Product Advisory (PA)

Subject: Change of the standard outer label of Renesas Electronics

Rev 1: December 8, 2025

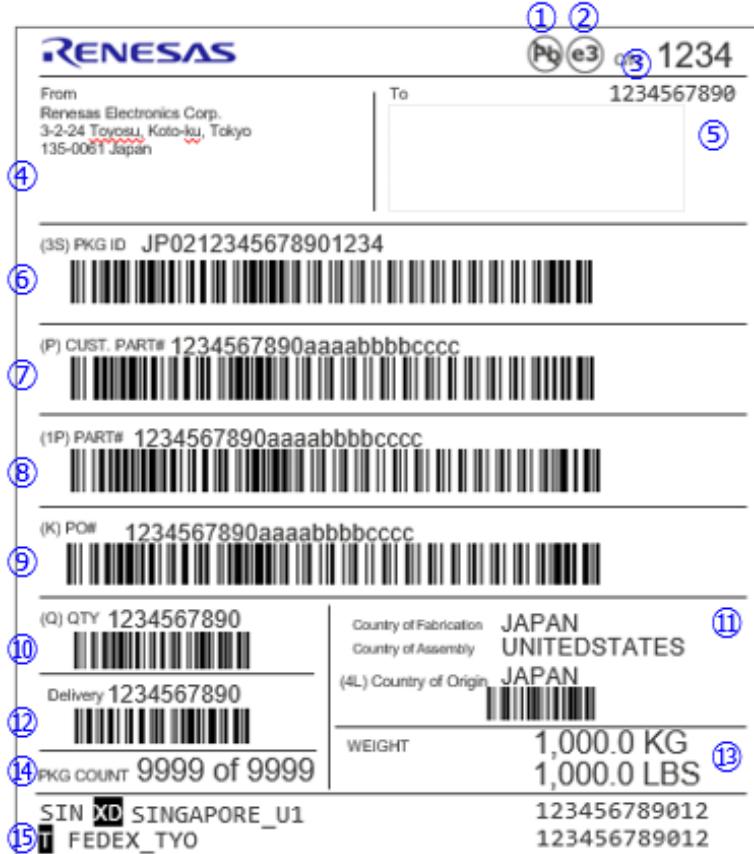
Rev 1: Update the country of origin on the outer label to show two countries: Fabrication and Assembly.

- ① Pb-Free's Logo Mark
- ② Pb-Free Detail Spec Rank
- ③ Case Number
- ④ From address
- ⑤ To address
- ⑥ Package ID
- ⑦ Customer Parts Number
- ⑧ Renesas Parts Number
- ⑨ Purchase Order Number
- ⑩ Quantity
- ⑪ Country Of Origin
- ⑫ Delivery Order Number
- ⑬ Gross Weight
- ⑭ Package Count
- ⑮ Renesas internal use area

GAP POINTS CURRENT AND NEW / REN-POWER (LEGACY INTERSIL)

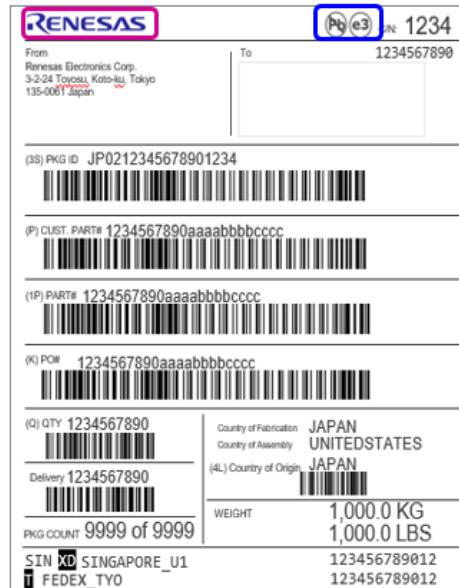
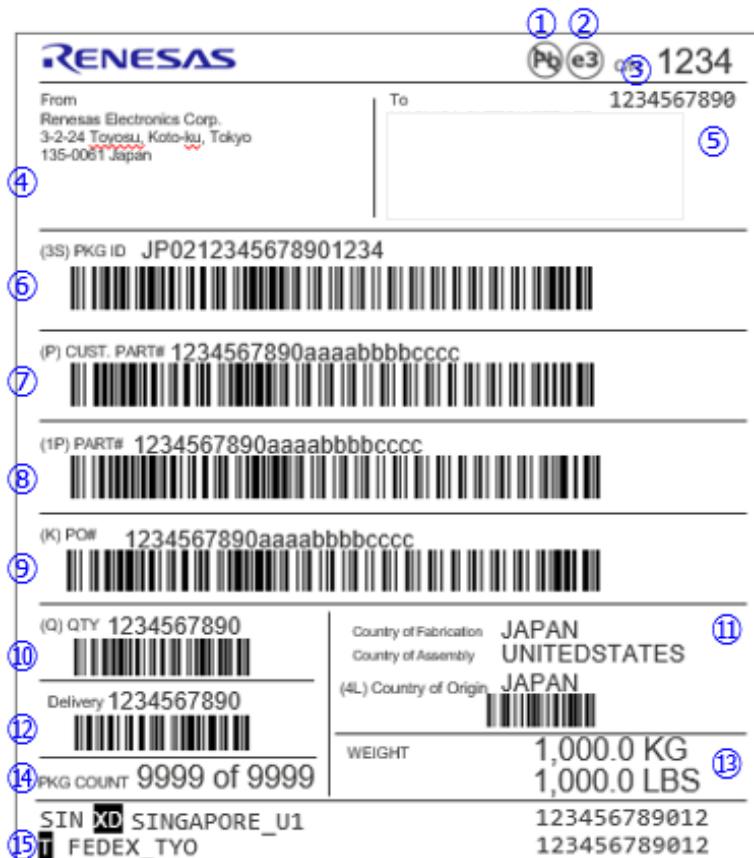
- Added Items**
Renesas Logo Mark
- Design Change Items**
Pb-Free's Logo Mark (RoHS Compliant)
- Delete Items**
MSL and reflow spec. (Move to inner label.)

GAP POINTS CURRENT AND NEW / REN-ANALOG (LEGACY IDT)

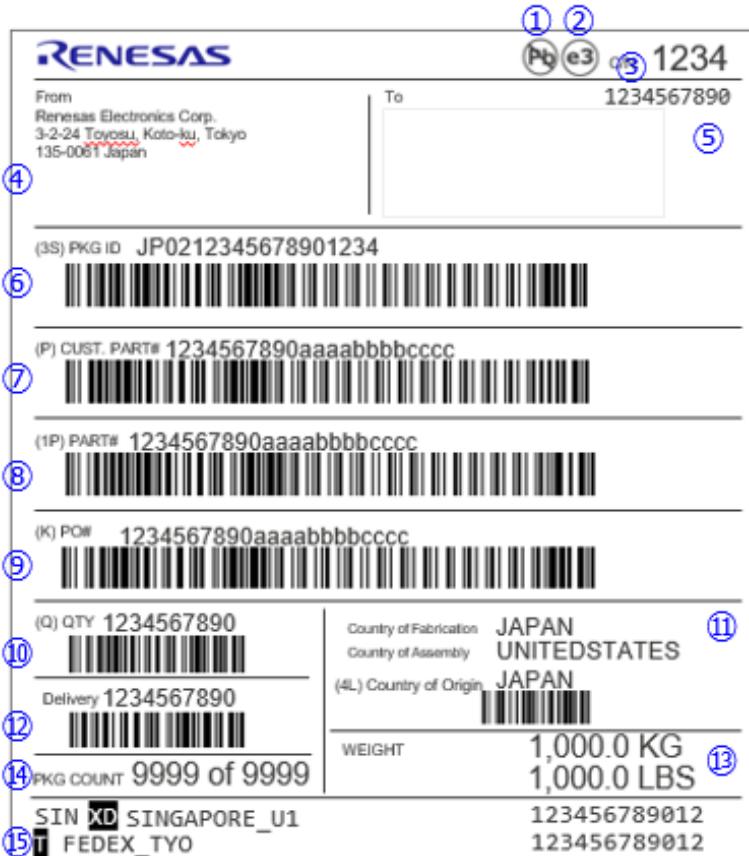
- Added Items**
Renesas Logo Mark
Pb-Free's Logo Mark
- Design Change Items**
Pb-Free's Logo Mark
(RoHS Compliant)
- Deleted Items**
D/C
(Move to inner label.)

GAP POINTS CURRENT AND NEW / REN-POWER & CONNECTIVITY (LEGACY DIALOG)

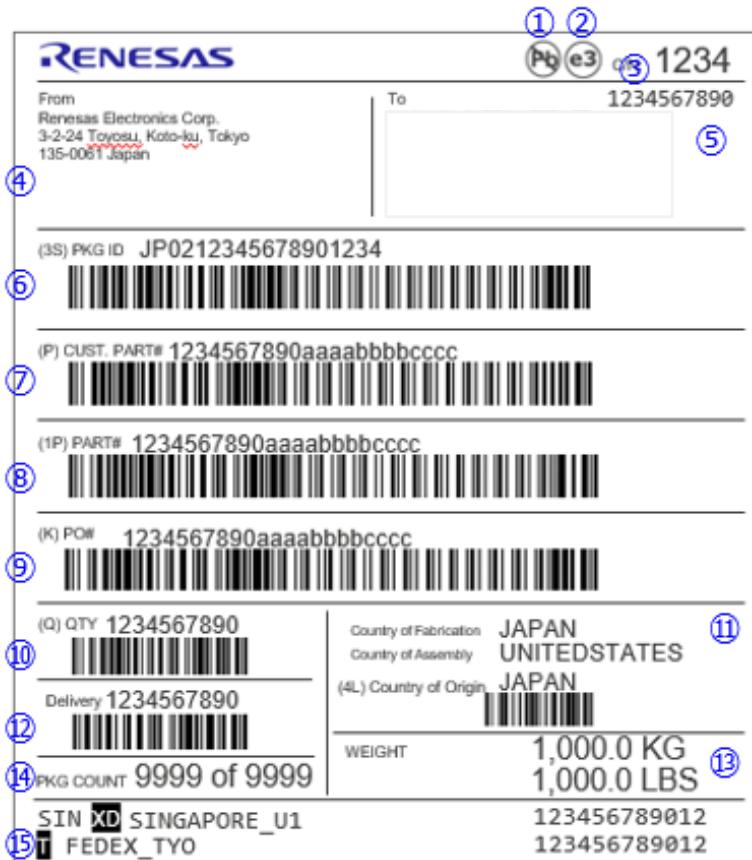
- Added Items**
Renesas Logo Mark
- Design Change Items**
Pb-Free's Logo Mark
- Deleted Items**
Supplier
Vender Code
INV NO.
